# FREDERICK COUNTY PLANNING COMMISSION

**TITLE:** S & R Management

**FILE NUMBER:** SP20-06 AP SP260355, A260357,  
F260212

**REQUEST:** **Site Development Plan Approval**

Graphic #1: Aerial

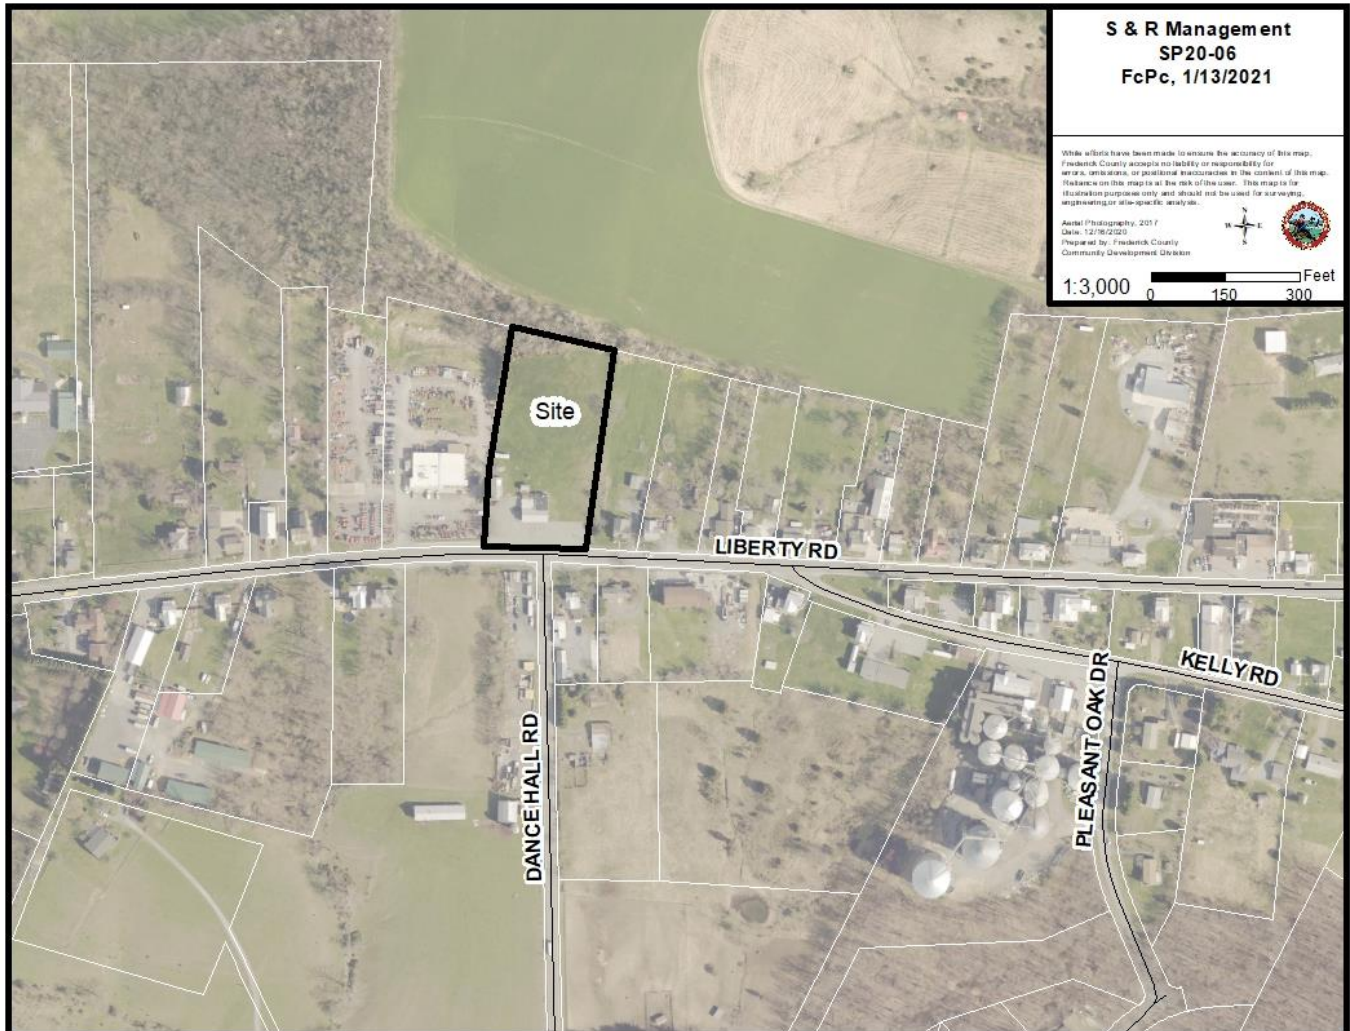
As required by Zoning Ordinance §1-19-7.500(D), Site Development Plan proposals in the VC Zoning District are required to submit plans to the Planning Commission or their authorized representatives for Concept Site Development Plan Approval. Due to the limited size of the proposed footprint, the application was reviewed at a staff level and approved on August 6, 2020. See Graphic #1 below.

Graphic #2: Zoning

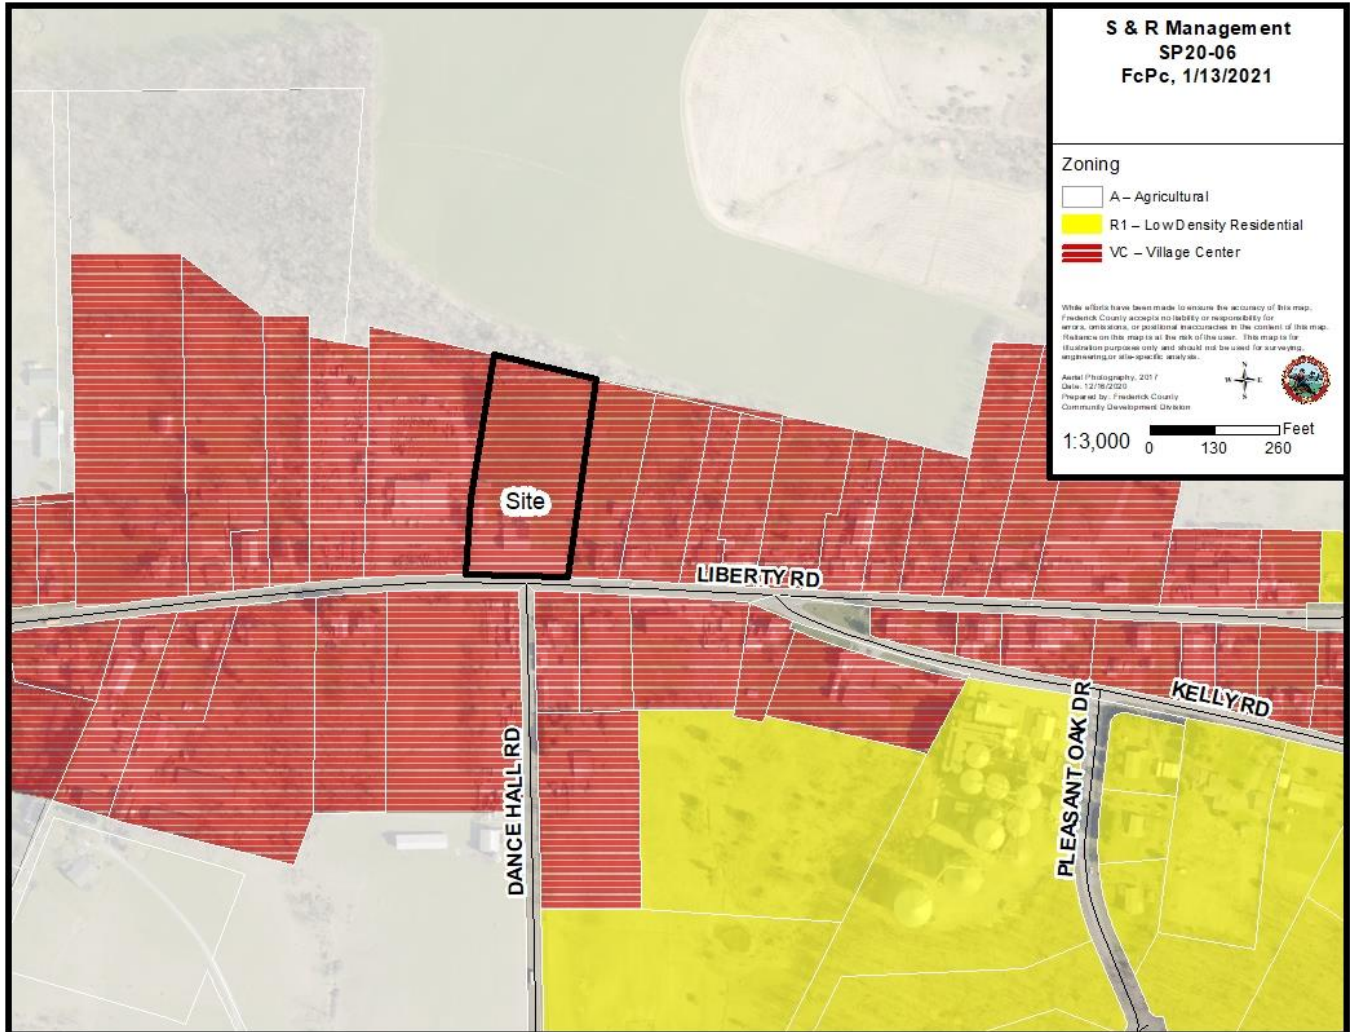
The Site is zoned VC, Village Center with a County Comprehensive Plan land use designation of Rural Community. The Site sits north of both an agricultural use and a residential dwelling (zoned VC), east of an existing commercial use (zoned VC), south of an agricultural use (zoned A), and west of a single family dwelling (zoned VC). See Graphic #2 below.
